PRODUCT
SUPPORT
BULLETIN # 500

TOOL(S) \ PRODUCT(S) AFFECTED: 2401-20 M12™ SUB COMPACT 1/4" HEX DRIVER

SUBJECT: **23-30-0095 MOTOR ASSEMBLY with NYLON or ALUMINUM Motor Mount Plate**
14-29-0095 GEARCASE ASSEMBLY with NON-MACHINED or MACHINED Gearcase

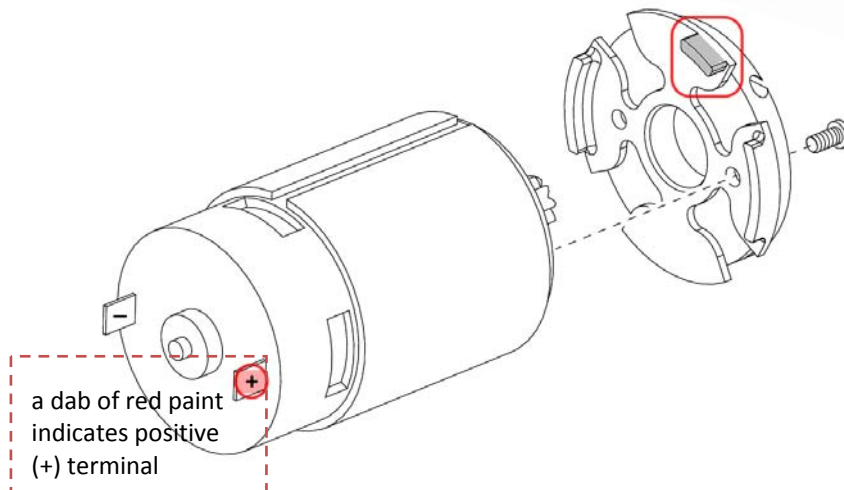
NON-MACHINED GEARCASE Nylon Motor Mount Plate must be used

Notch for Nylon Motor Mount Alignment Tab will be utilized

MACHINED GEARCASE Aluminum Motor Mount Plate must be used

Gearcase has machined undercut

note: highlighted small tab of Motor Mount Plate (*either NYLON or ALUMINUM*) must-be-in-line with positive (+) terminal side of motor as illustrated to allow for correct placement of the motor and wiring in the handle of the tool

When replacing either the 23-30-0095 MOTOR ASSEMBLY or 14-29-0095 GEARCASE ASSEMBLY the mating of the motor assembly with the gearcase is **dependent on the original motor mount plate** of 2401-20 Hex Driver being serviced. If a 2401-20 Hex Driver **original motor** has a nylon motor mount then replace any service replacement MOTOR ASSEMBLY aluminum motor mount with the original nylon motor mount plate from the original motor before installing it to the gearcase and vice versa - if the original motor has a aluminum motor mount then replace the service replacement MOTOR ASSEMBLY nylon motor mount with the original aluminum before installing to the gearcase.
